SERVICE INFORMATION

Type(s): 6121, 6126, 6700, 6701, 6702, 6703, 6704, 6705

SUBJECT: CHECK PAWL, SPRING, STUD AND TAB KEYLEVER - REDESIGNED

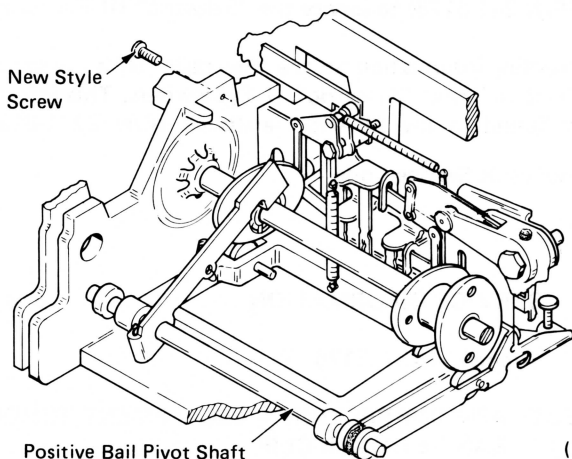
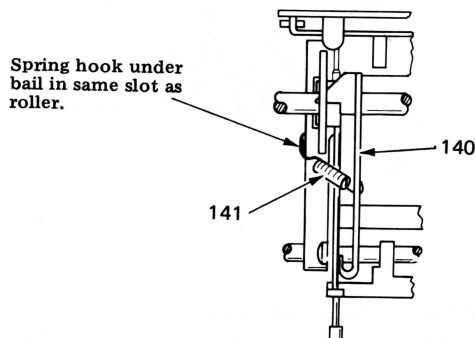
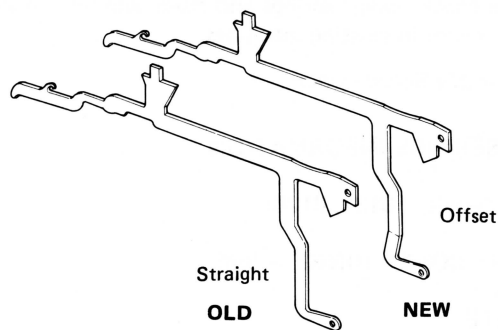
The cycle clutch check pawl, stud and spring has been designed to improve cycle shaft cam stop location (Figure 1).

The new pawl (23-140) is now mounted on the positive bail pivot shaft (23-118). The screw (23-142) replaces the studs (23-417, 423). The studs (23-417, 423) will remain available for replacement on old level machines (Figure 2).

The pawl is spring loaded to the left by spring (23-141), and is connected to the positive bail as shown in Figure 3.

(Figure 4)

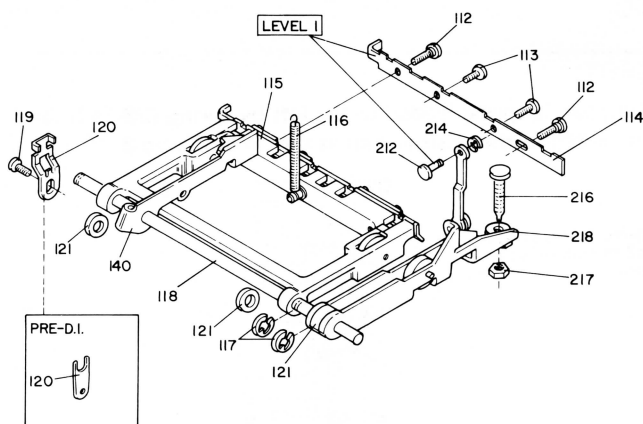
The tab keylever (18-28, 19-43) has been redesigned (Figure 4), to ensure there is no interference between the check pawl (23-140) and tab keylever. The new redesigned tab keylever will work on all level machines. The old level keylever will be obsolete. Scrap all old level keylevers and reorder new style.

SUBJECT: BACKSPACE DRIVER MOUNTING STUD -B/M

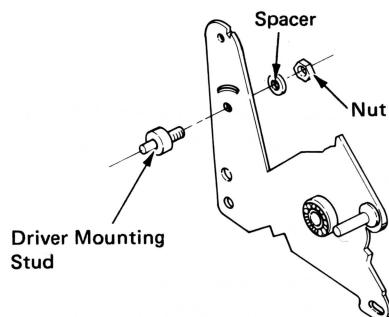
Backspace failures due to a broken driver mounting stud may be corrected using the backspace driver mounting stud B/M.

1. Remove driver mounting stud from backplate by tapping lightly.
2. Remove the "C" clip, washer, driver, pitch cam (disconnect pitch cable), and pitch cam spring from the stud.
3. Insert the new stud (24-155) in the pitch cam spring, pitch cam (connect pitch cable) and driver.
4. Install washer and "C" clip on the front of the stud.
5. Install stud through the hole in the backplate and secure with washer and nut (Figure 1).

SUBJECT: STROKE COUNTER - REDESIGNED

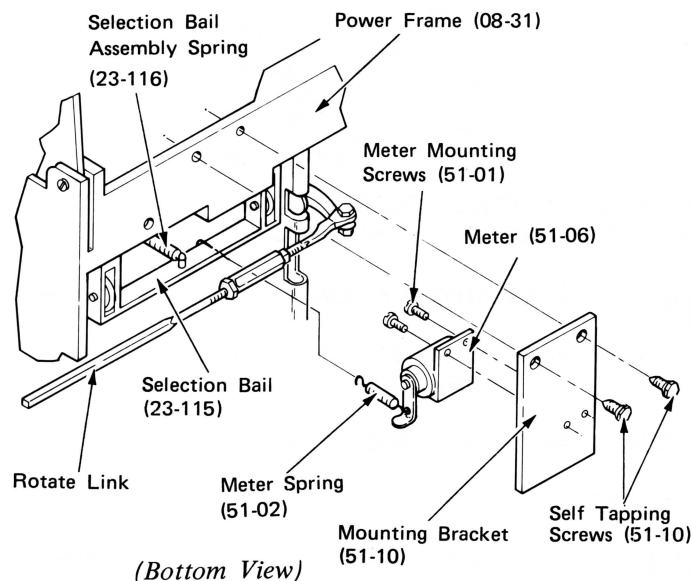
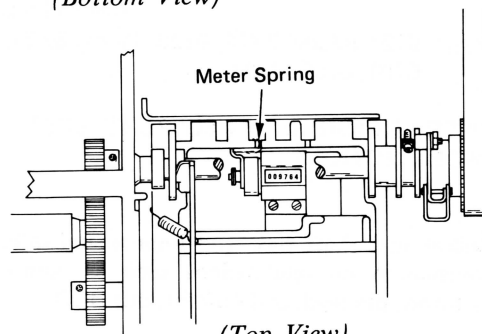
The "Selectric" stroke counter has been redesigned to mount on the bottom of the power frame as illustrated in Figure 1. A new field installable B/M (51-9) is available which contains the hardware and counter. The only ratio available for new installations is 120:1.

Adjust the bracket or the counter front to rear so that the arm gets enough motion from the positive bail to advance the counter.

SUBJECT: OPERATIONAL SHAFT SUPPORT (LOST INDEX MOTION)

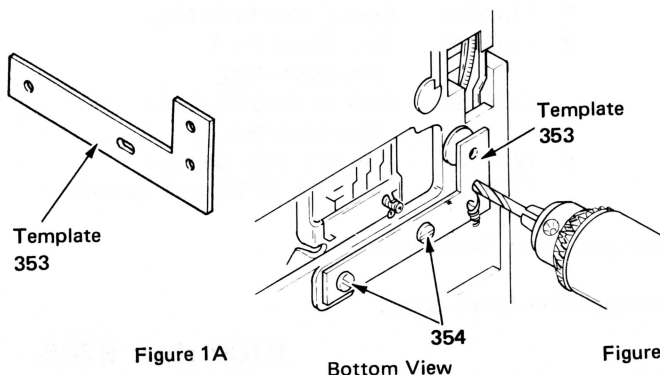
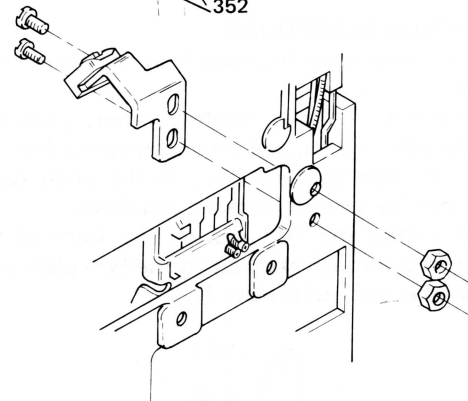
To reduce operational shaft flex, and improve reliability of the index mechanism on applications such as continuous multiple copy forms, pin feed, and 45/48 tooth OCR.

1. Attach the drilling template (Figure 1A) to the machine frame as shown in Figure 1B. Drill the two holes with a No. 22 drill bit (P/N 450265) and remove template.

2. Assemble and install the operational shaft support bracket asm. as shown below (Figures 2A and B).

3. Position the operational support bracket front-to-rear so the front of the bracket evenly contacts the power frame as shown in APM, frame 134.
4. Perform adjustment APM, frame 135.

SUBJECT: PINFEED PLATEN SUPPORT B/M (A-FRAME ONLY)

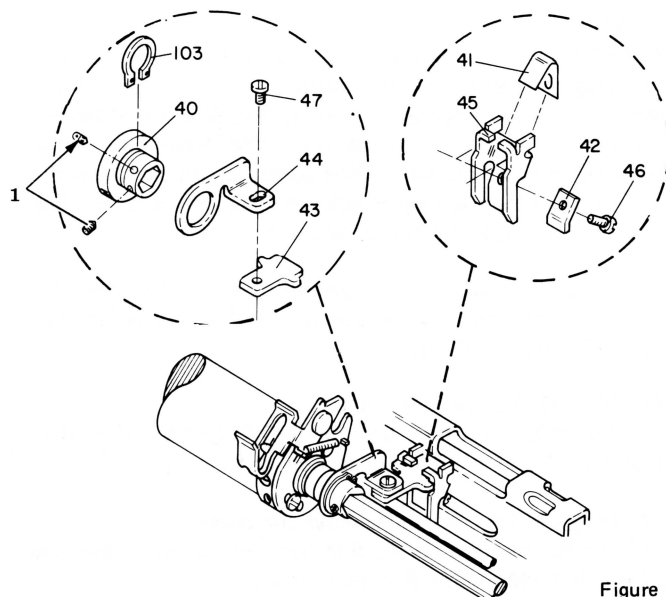
A pinfeed platen support B/M (49-50) is now available to reduce movement of the pinfeed platen caused by typehead impact. [Max. pin to pin approx. x5, 10" (254.0 mm) — x3, 9 1/2" (241.30 mm) — x1, 6" (152.40 mm)]

Smeared characters.

Install the support B/M (49-50) on the right side of the platen (Figure 1) as described below:

1. Remove platen asm. and deflector.
2. Remove LH platen knob, LH platen bushing, pinwheels and core.
3. Assemble support bracket asm. (49-01, 40, 103, 47, 44, and 43) as shown.

4. Install the support bracket asm. on the platen shaft as shown. Do not tighten screws (49-47 and 01).
5. Install the pinwheels, core, LH platen bushing and LH platen knob; tighten only the platen knob screws.

6. Hold the support bracket asm. up in a vertical position while installing the platen.
7. Position the pinwheels and core as far to the left as possible and tighten the pinwheel setscrews.

8. Remove platen asm. and center cover.
9. Install the base (49-45) and guide spring (49-41) on the front of the A-Frame in the slot as shown. Attach with clamp (49-42) and screw (49-46) as shown. Leave screw (49-46) loose at this time.
Note: End of guide spring with hole should be between the base and A-Frame.

10. Guide the support bracket (49-43) under the extension of the support base (49-45) while installing the platen asm.
11. Slide support base asm. and support bracket asm. as close to the RH pinwheel asm. as possible.

12. Hold the support base (49-45) down against the paper release rod (22-269). Position the spring (49-41) so the support bracket (49-43) will slide under the extension of the support base (49-45) without bending the spring (49-41). Then tighten the screw (49-46).

13. Hold the support bracket (49-43) so that the extensions touch each side of the support base (49-45) while tightening the bushing screws (49-1).
14. Hold the support bracket (49-43) to the rear (both extensions touching the support base) while tightening the screw (49-47).
15. Remove the platen.
16. Install center cover and deflector.
17. Guide the support bracket (49-43) between the deflector and the center cover while installing the platen.

SUBJECT: POSSIBLE CE SAFETY EXPOSURE — LINE
CORD, MOTOR PULLEY CONTACT

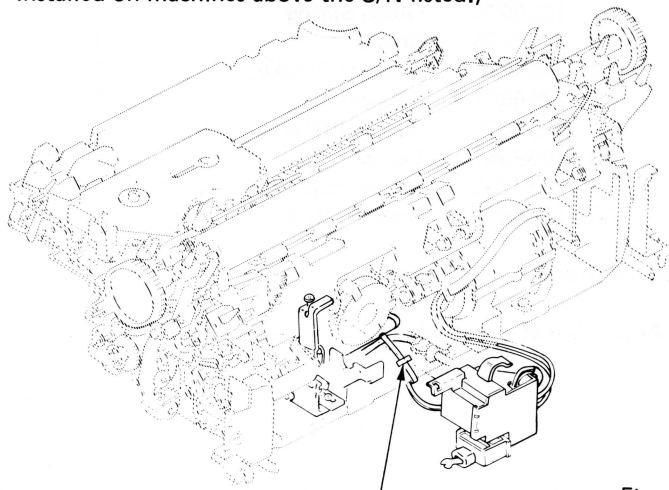
PRECAUTION: The motor shell could become live (i.e.,
line voltage present on the motor shell) on dual pitch
"Selectric" IIIs manufactured prior to the S/Ns listed below.
The length of the line cord from the white strain relief to the
transformer may be excessive. The added length can allow the
cord to contact the motor pulley/shaft. This may wear the line
cord insulation, resulting in the shell becoming live.

1. Unplug the line cord and remove the covers.
2. Check for damage to the line cord insulation in the area
indicated and replace it if damage is evident.
3. Install wire tie (11-606) as shown in Figure 1.
4. Reapply power and check for proper machine operation.

NOTE: All machines within the specified S/N range must be
checked for this condition on the next service call. The wire
tie must be installed on **ALL** machines. (The wire tie is plant
installed on machines above the S/N listed.)

SUBJECT: PAWL MOUNTING STUD

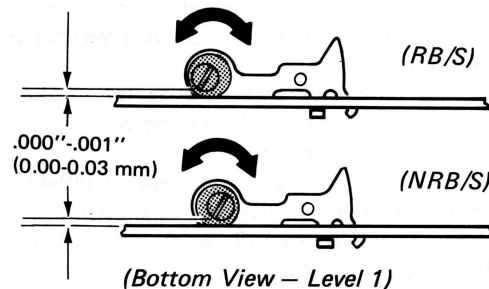
Frame 119 of APM 241-5939-3 is incorrect. On NRB/S
machines, the eccentric screwhead should be to the left and on
RB/S machines, the eccentric screwhead should be to the right.
This correction is shown in Figure 1. Mark this change in
your APM.

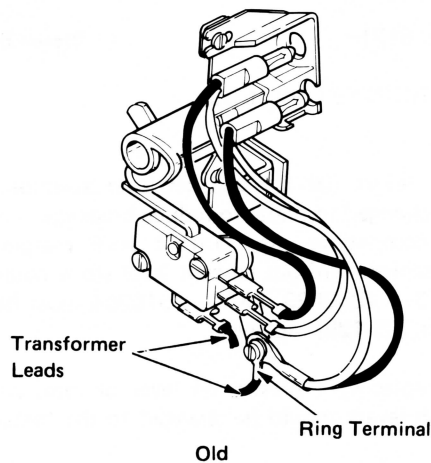
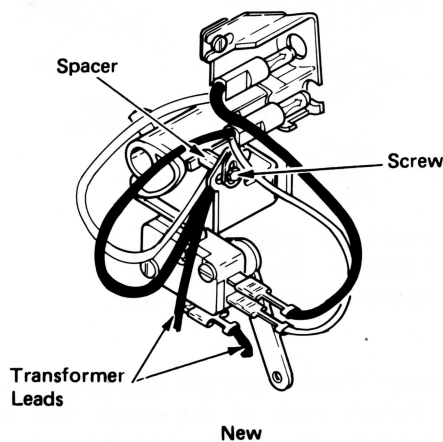
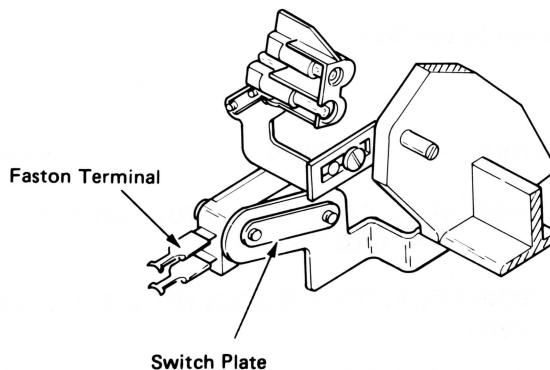
A new motor has been released that includes a built-in transformer to provide margin lamp voltage for "Selectric" III 115V — 60Hz dual pitch machines.

The method of connecting the secondary wiring at the margin light switch plate (10-109) has also been changed. Figure 1 shows the old method of connection and Figure 2 shows the new. The switch plate will be redesigned as illustrated in Figure 3. The old plate will be used until stock is depleted but the wires will be connected as illustrated in Figure 2.

If a transformer motor is used as a replacement part, the new method of wiring (Figure 2) must be used. It is not necessary to change the wire connections on machines with the previous transformer (11-603).

SUBJECT: TOP COVER JAMMED – SOUND REDUCTION MACHINES

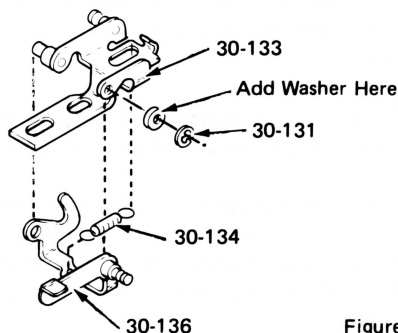
If experiencing problems in lifting the top cover (30-151) on sound machines, check for excessive side-to-side motion of the hood latch on the RH hood bracket (30-133). The top cover latch (30-136) may have slipped off the RH side of the bracket (30-133) and jammed the cover. Washer (P/N 1091220) has been used in the plant to eliminate the problem and can be used if needed in the field. Install washer as shown in Figure 1.

Figure 1

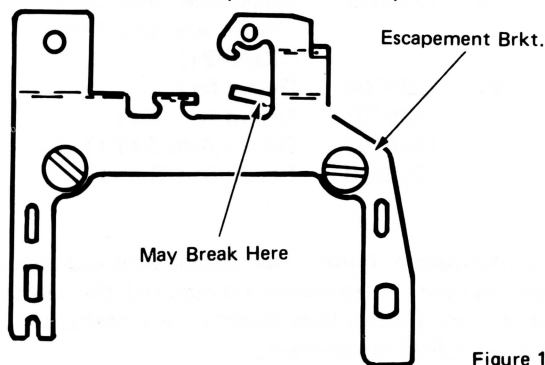
The tab torque bar back up lug on the escapement bracket may break when formed (Figure 1).

If this condition occurs replace the escapement bracket.

Figure 1

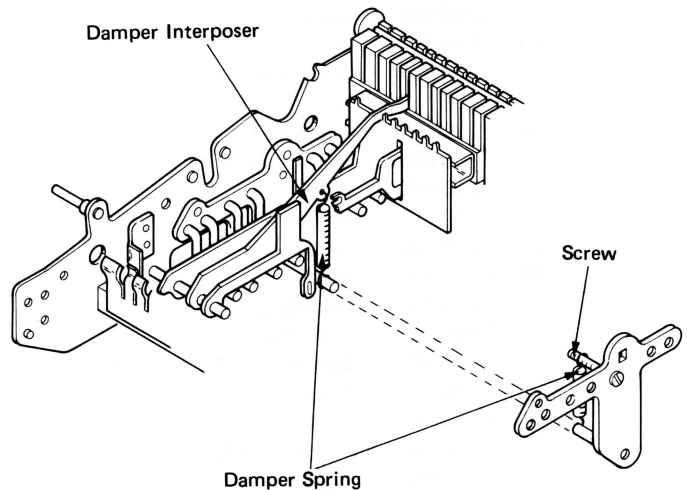
The cycle clutch bail leaf spring (21-240) has been replaced with coil springs on both sides of the key board. This change was made in order to maintain a more reliable adjustment of the cycle clutch latch pawl to keeper on the assembly lines. It will also allow the touch to be distributed more evenly across the keyboard.

The LH spring (21-210) is connected to an interposer (21-113) that has been added to the LH side of the keyboard (Figure 1). The right and left damper springs can be installed in keyboards in the field by ordering the interposer, screw, and springs. On the RH side replace the center screw in the plate with the longer screw that was ordered and attach the spring. The center leaf spring will remain available.

SUBJECT: CORRECTION LIFT GUIDE RESTORE SPRING REDESIGNED

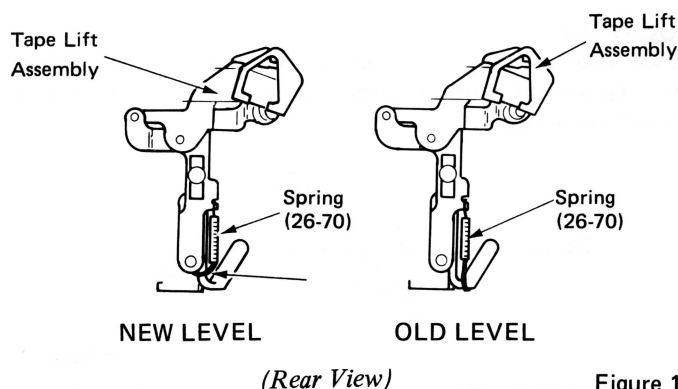
The correction lift guide restore spring (26-70) has been redesigned to prevent the bottom loop from contacting the D.I. cable or dust shield. The new shorter spring hooks in a corner of the lift bracket as shown in Figure 1.

Figure 1

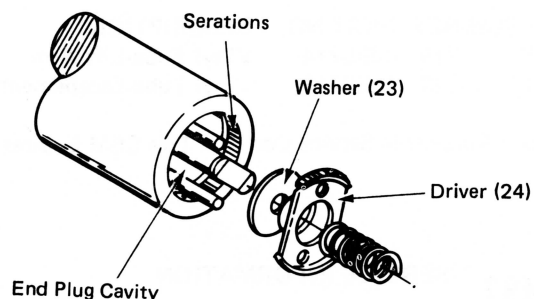
Some machines were manufactured with the potential of preventing the platen driver from fully engaging the platen. This may be caused by either an interference between the cavity in the platen end plug and the washer (12-23) — fig. 1, or small pieces of plastic end plug material that may become lodged between the driver (12-24) and the end plug serrations. If experiencing this condition, clean out the platen end plug and replace the existing washer with the current smaller diameter washer PN1359915.

SUBJECT: APM CORRECTION - RIBBON CASSETTE

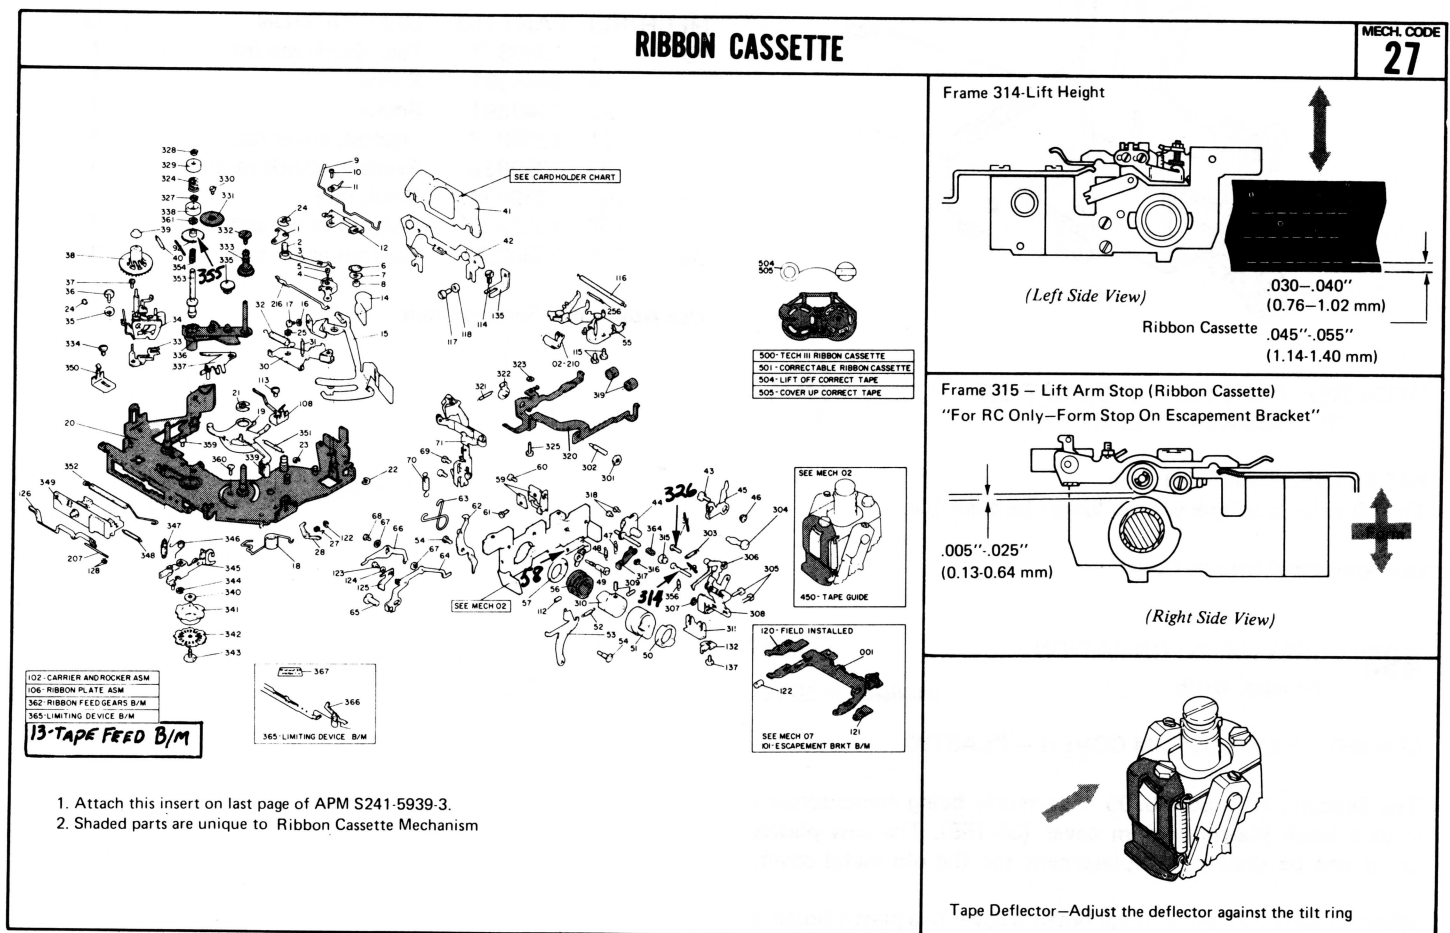
Mark the following changes to the mechanism 27 attachment of your APM.

Change Ref. 92 to 355

Change Ref. 19 to 314

Change Ref. 31 to 326

Add Ref. 58

Add Ref. 13

SUBJECT: INDEX LINK REDESIGNED

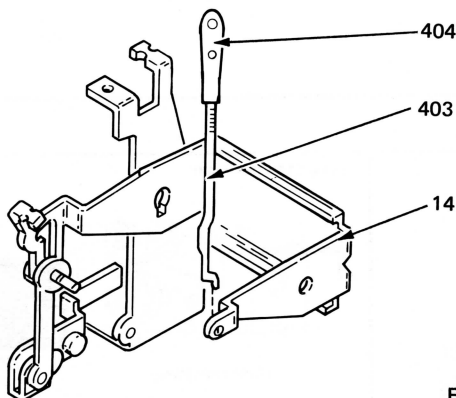
The lower end of the index link (20-403) has been changed to improve reliability. The new link utilizes an offset in place of the permanently mounted clevis. The new link may be installed by first removing the trigger restore spring (07-41). Install the offset end of the link as shown in figure 1. Then attach the clevis to the link from the top of the machine.

Figure 1

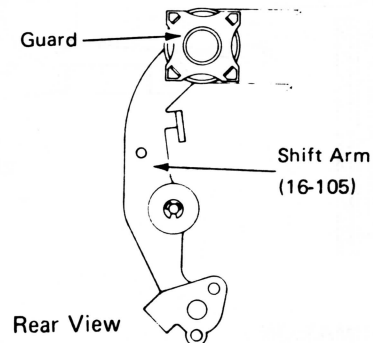
To reduce repeated rotate tape replacement caused by the tape becoming disengaged from the shift arm pulley, the Mag Card velocity tape guard (25-34; P/N 1457036). may be installed. Prior to installing the guard, ensure that a machine malfunction is not causing the tape problem. Install the guard as shown in figure 1.

NOTE: Due to a tolerance build-up of the related parts (shift pulley, rotate tape and velocity guard), a binding condition may occur on some machines. Reducing the length of the velocity guard tips by sanding, filing, etc., will reduce the binding condition.

Figure 1.

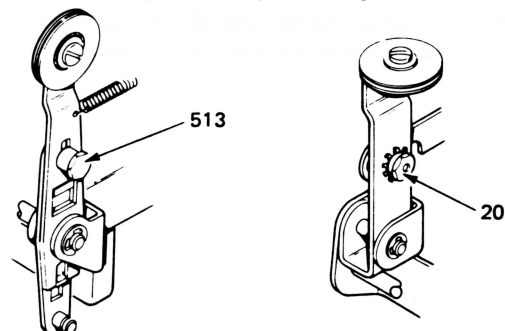
Manufacturing has redesigned the rotate arm screw (23-513) and the tilt arm nut (23-20) for the purpose of using an automated selection adjustment system (Fig 1).

Figure 2

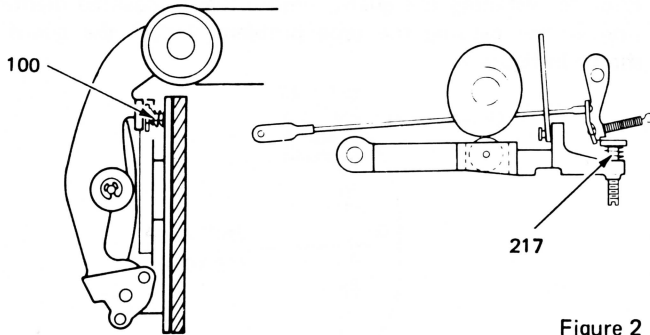
Compression springs were also designed to replace the shift arm stop screw lock nut (16-100) and the negative bail adjusting screw lock nut (23-217, Fig 2). However, due to manufacturing problems, the use of the compression springs has been discontinued.

A limited number of machines have reached the field with compression springs that may allow the stop screw(s) to move. If experiencing problems with varying selection adjustments, install the appropriate lock nut (16-100) or (23-217) to correct this condition.

Figure 1

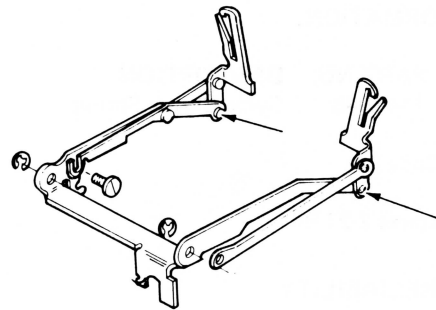
A number of machines were manufactured with defective fabric ribbon lift guide (13-37) rivets (Fig. 1). The rivet hardness and assembly method were changed to reduce breakage. If experiencing ribbon lift failures, check for either a loose or broken rivet and replace the lift guide assembly as necessary.

Figure 1

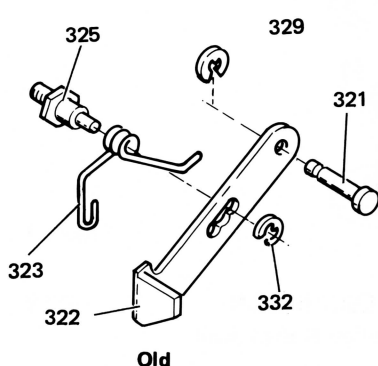
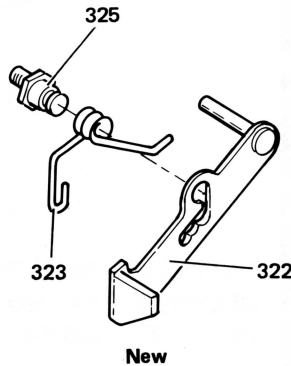
The selector cam lever (20-322) and stud (20-321) are now one piece. Additional stability is provided by the selector cam lever (20-322) interlocking with the adjustable stud (20-325). The tension spring (20-323) was modified to accommodate the adjustable stud (20-325). "C" clips (20-329) and (20-332) are not required with new level parts.

PARTS INFORMATION: The previous level parts (321, 322, 323, 325) are no longer available. New level parts are not compatible with previous level; if replacing an old level part, new level (322, 323, 325) must be installed.

Figure 1

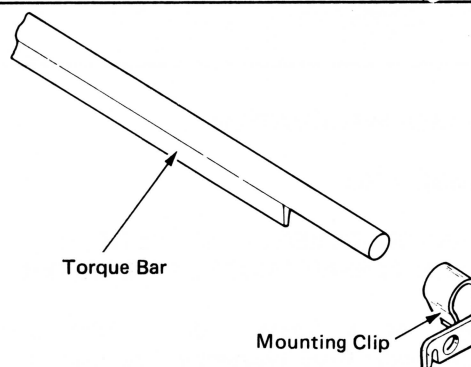
The Pre-Floating torque bar P/N 1206100 has been replaced by a B/M. The new B/M includes a Mag Card torque bar and two clips. When installing the B/M, remove the Mag Card torque bar spring anchor and install the new link mounting clip (Fig 1). A clip is included which should be used to control torque bar end play.

NOTE: After removing the Mag Card torque bar spring anchor, use a file to remove sharp edges.

Carrier Yoke

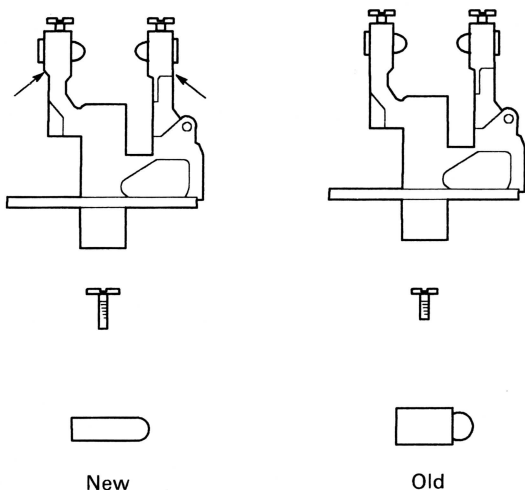
Selectric® carrier yokes (02-520) have been improved by increasing the thickness of the uprights and by decreasing the diameter of the tilt ring pin hole. These yokes require smaller diameter tilt ring pins (02-301) and longer tilt ring pin screws (02-302). See Figure 1.
